PE09-024

ATTACHMENT Q8

Q8 DOC 1 ODYSSEY

QUALITY IMPROVEMENT SHEET (Q.I.S.)

Investigation results

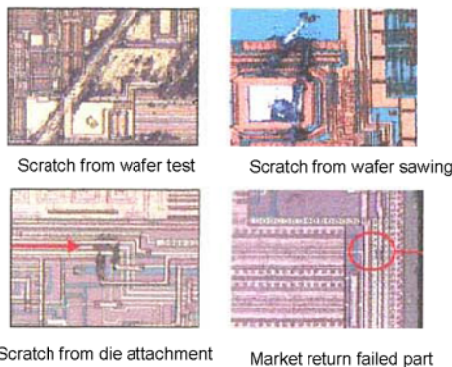
Size of scratch confirmed by internal analysis is approx. 10um and investigation of equipments (area where it comes into direct contact with the wafer) which are used in assembly process after formation of protective film, revealed that all of them were larger than the scratch on the market return part.

Scratch recreation test was carried out with equipments, and found that both the size and configuration differed from that of the market return parts (See photos on right.)

Outflow countermeasure
 Before the final test hot_O/S_test has been added (temperature requirement: [Redacted]) starting 7th March, 2005 (HM delivery date of countermeasure part: Since 15th June, 2005)
